# Accessibility Audit

Prepared by Direct Access Consultancy LLC

Westford Schools, Children's Centers & Museum

Westford, MA 01886

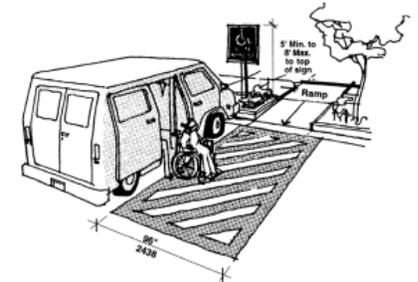
Budgeting Range:

2006 521 CMR Section: 23.6, 23.6.2

#### Recommendation:

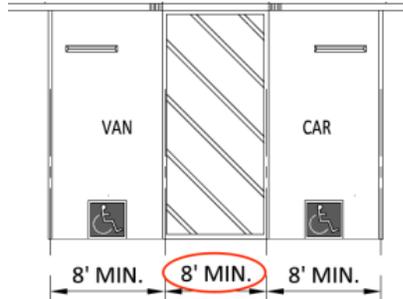
1991 ADAS Section: 4.1.2(1)

2006 521 CMR Section: 23.4.6(b)

In the two van size spaces in the main parking are ensure each van sized space contains a 96" access aisle.

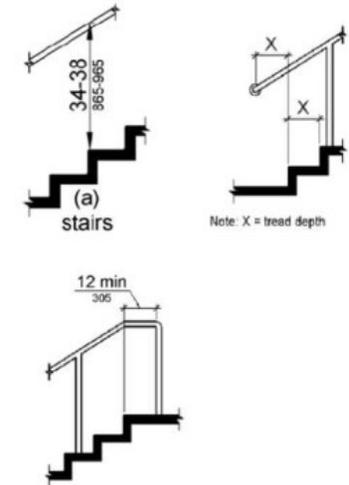
2010 ADAS Section 505.2  
Handrails shall be provided on both sides of stairs and ramps.

2006 521 CMR Section 27.4.1  
Location: Stairways shall have continuous handrails at both sides of all stairs. The inside handrail on switchback or dogleg stairs shall always be continuous. See Fig. 27c.

<b>Citation:</b>	<b>Budgeting Range:</b>
2010 ADAS Section: 505.2	\$1,500 - \$7,500.00
2006 521 CMR Section: 27.4.1

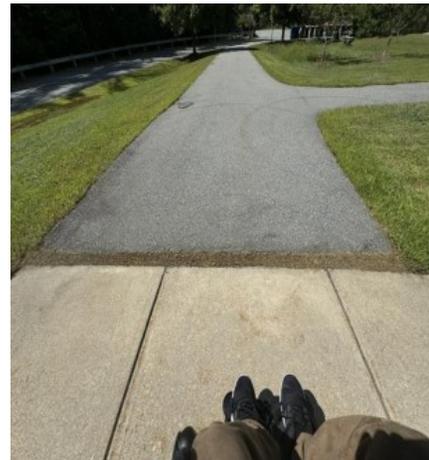
Openings in floor or ground surfaces shall not allow passage of a sphere more than 1/2 inch (13 mm) diameter except as allowed in 407.4.3, 409.4.3, 410.4, 810.5.3 and 810.10. Elongated openings shall be placed so that the long dimension is perpendicular to the dominant direction of travel.

2010 ADAS Section: 302.3 \$150 - \$550.00

Remove grass and weeds and patch or repour asphalt on all areas with gaps greater than 1/2" in width.

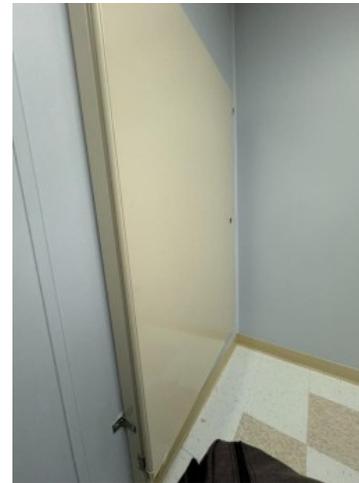
2006 521 CMR Section: 30.6.1(d)

Remove shelving unit and consider other option for storing supplies within the accessible toilet compartment.

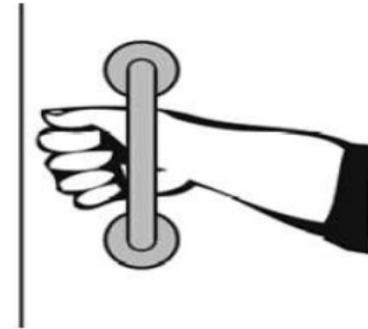
1991 ADAS Section: 4.13.9

2006 521 CMR Section: 30.6.1(b)

Install loop handle on both side of accessible toilet compartment door

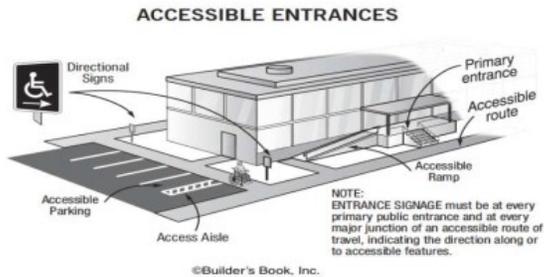
\$3,500 - \$9,500.00

Install an accessible route of travel from the accessible parking area over to the bench by the tree and from the accessible parking area to the concrete surface where access to the ramped entrance to the building begins.

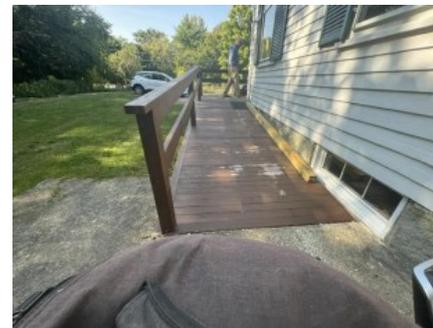
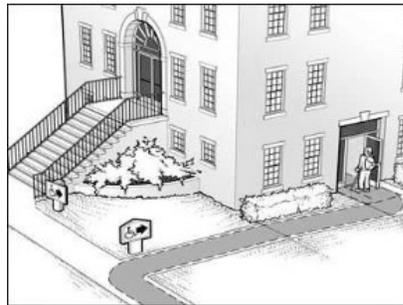
2006 521 CMR Section: 0.0

Replace and refinish the several boards which are rotted and no longer support individuals

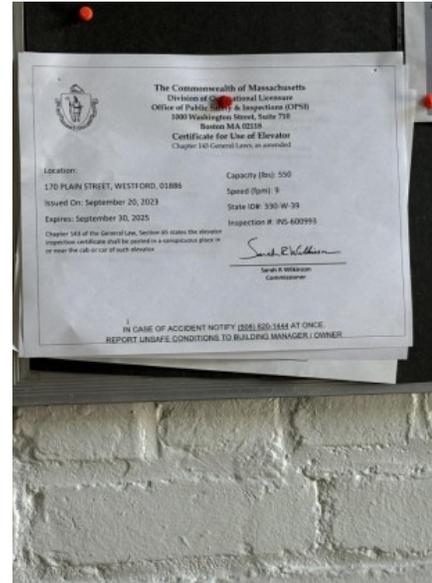
The elevator certificate states that the platform lift motor is rated to a maximum of 550 pounds. Adult electric wheelchairs average 400 pounds just for the chair while a pediatric electric wheelchair averages 325 pounds. This is before you add the weight of the user. Children and adults are much heavier today than in the past, so lifts installed must address the needs to accommodate this population of individuals.

Investigate installing a new motor with a weight capacity on the order of 800 to 1,000 pounds for safety and inclusion purposes. Ensure that the lift is not used as a storage area for teaching materials.

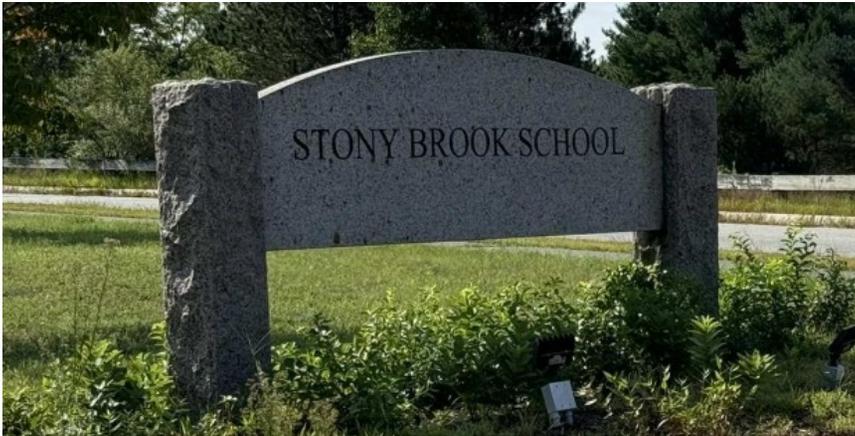
\$1,500 - \$4,500.00

Investigate the possibility of making the entire kitchen area accessible for someone who uses a mobility device for inclusion purposes.

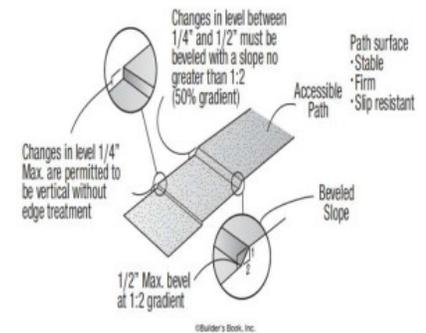
2010 ADAS Section 302.1  
Floor and ground surfaces shall be stable, firm, and slip resistant and shall comply with 302.

1991 ADAS Section 4.5.1  
Ground and floor surfaces along accessible routes and in accessible rooms and spaces including floors, walks, ramps, stairs, and curb ramps, shall be stable, firm, slip-resistant, and shall comply with 4.5.

2006 521 CMR Section 29.1  
Ground and floor surfaces including floors, walks, ramps, and curb cuts shall be stable, firm, slip resistant, and maintained with materials that ensure continued slip resistance.

**Citation:** 2010 ADAS Section: 302.1  
**Budgeting Range:** \$500 - \$4,500.00
